Architect's Supplemental Instructions

Architect's ASI No: 049

Project:
Webster University
Interdisciplinary Science
Building

SHEET E0101.A LEVEL 01 AREA A FLOOR PLAN – ELECTRICAL & AUXILIARY

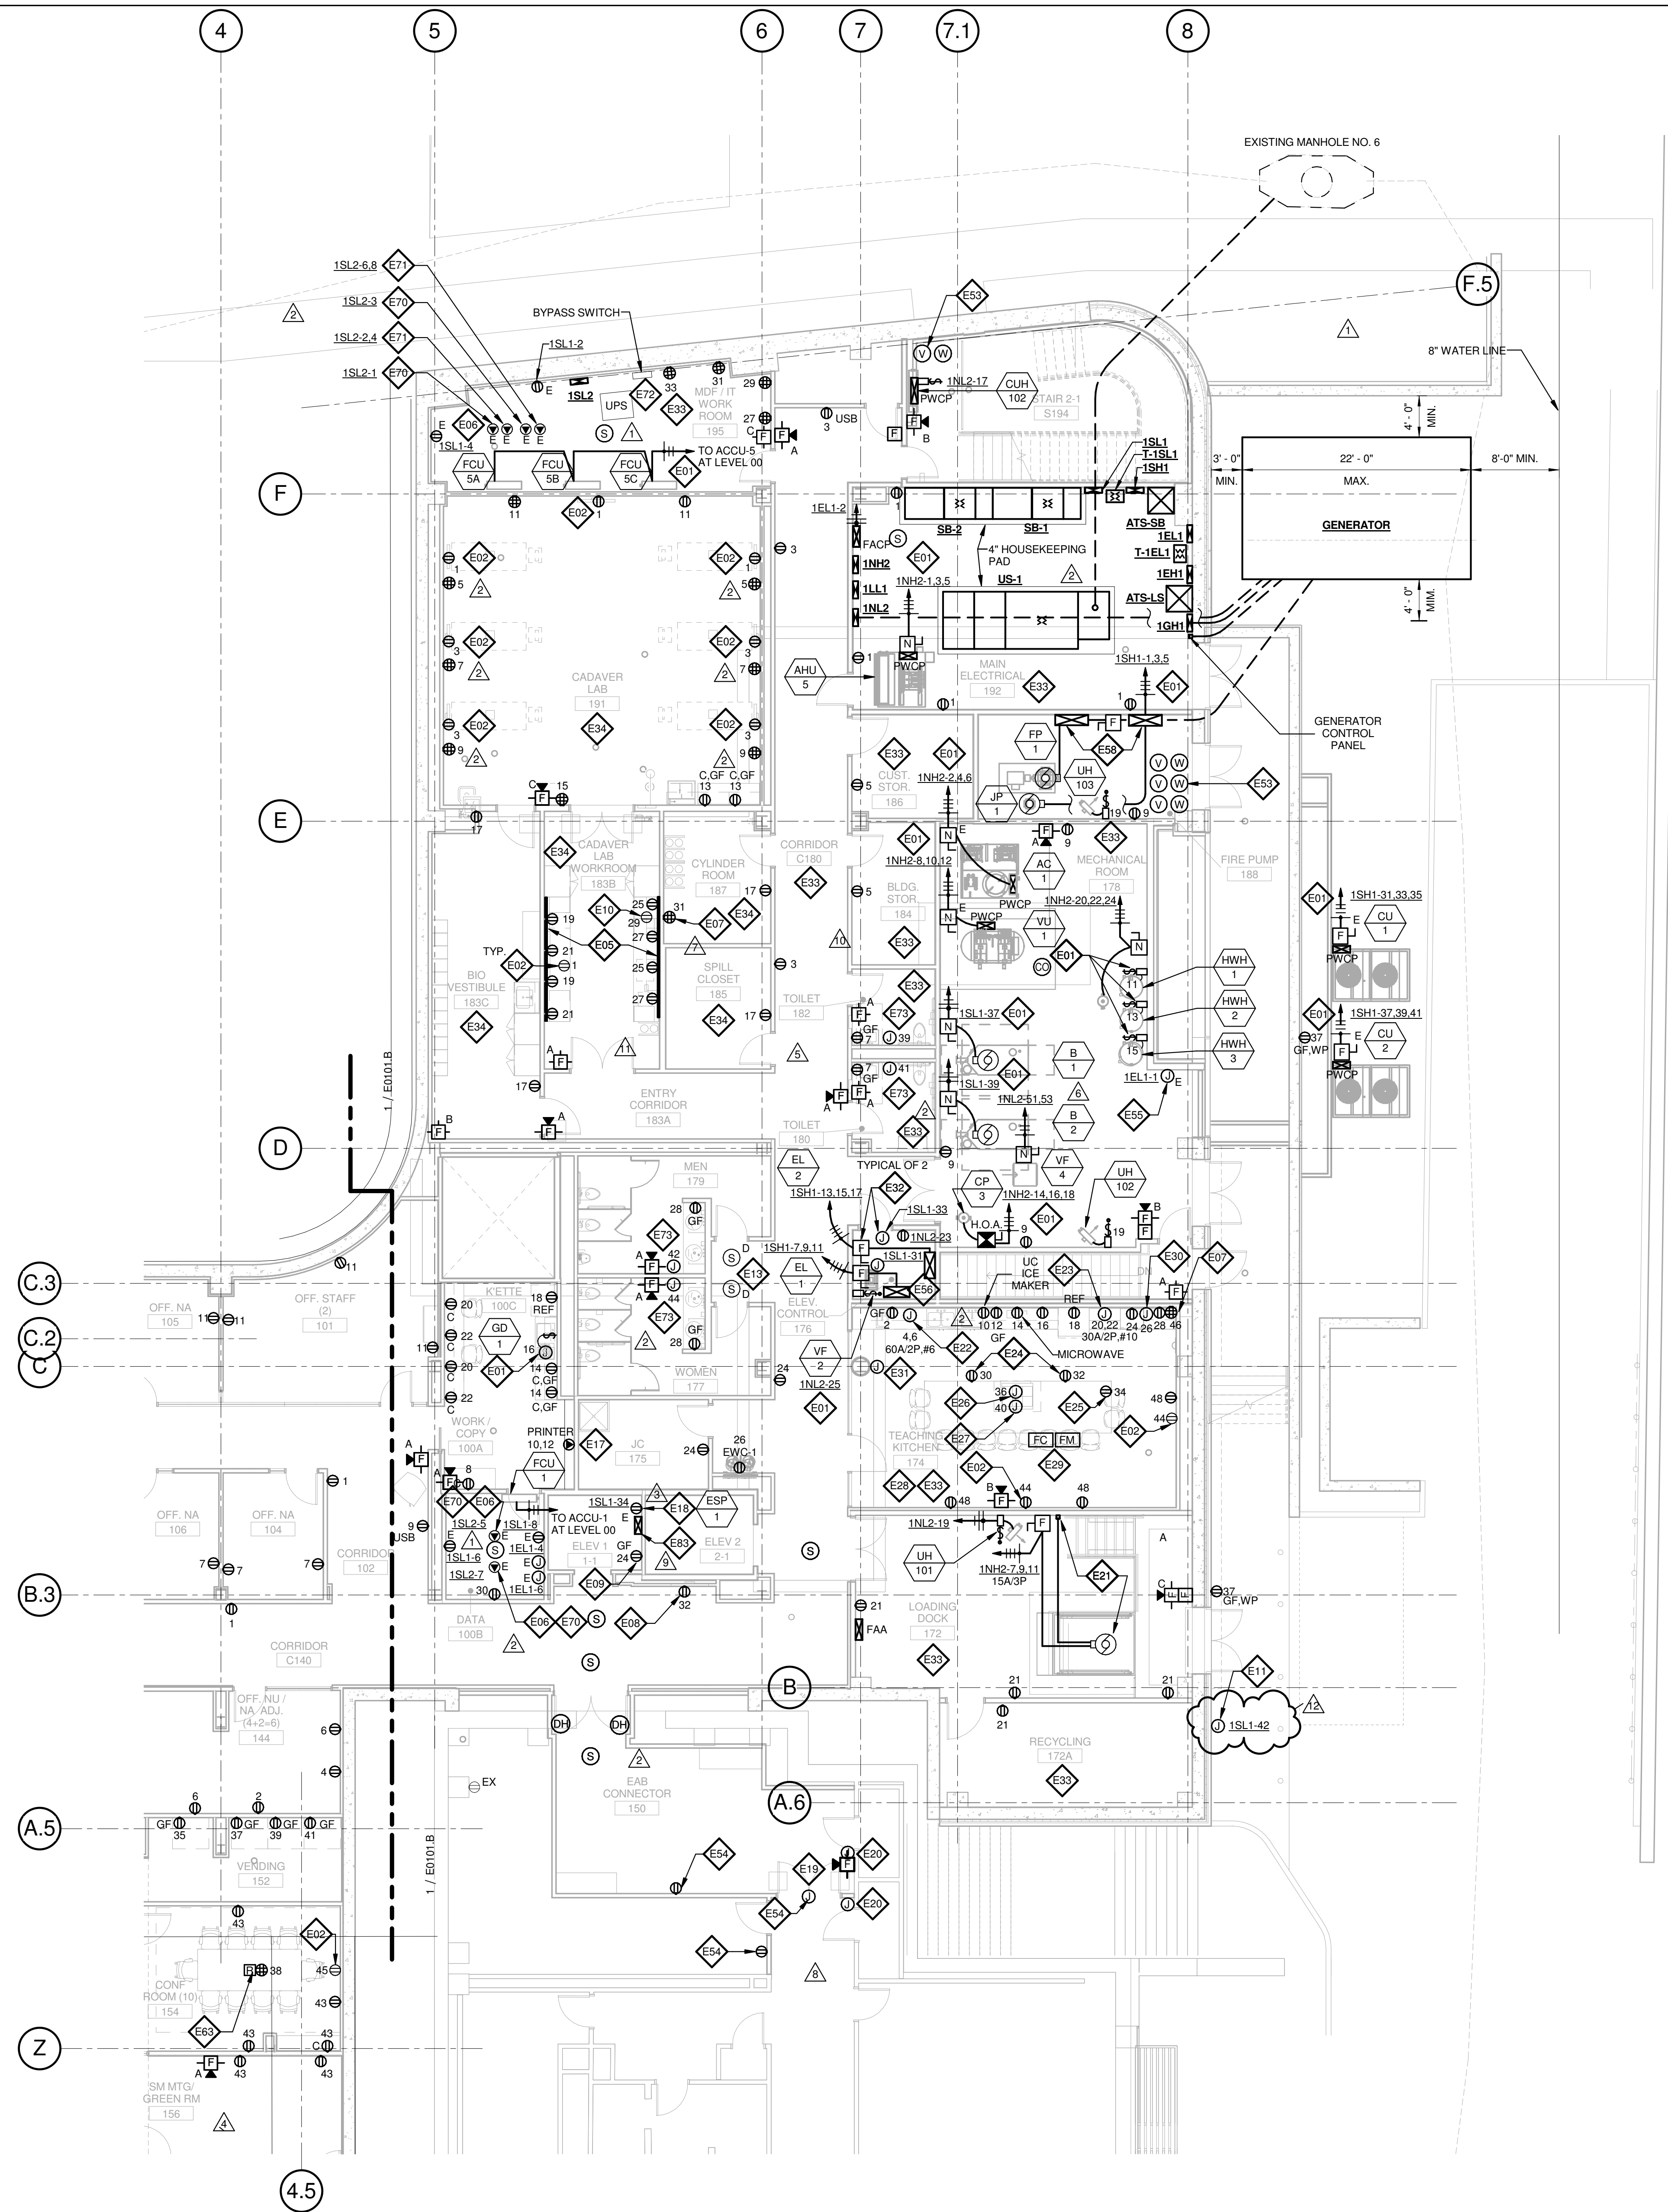
- Near EAB/ISB entry stairwell, connect emergency call box (Keyed Note E11) to emergency circuit 1SL1-42 in-lieu of normal power circuit previously shown.
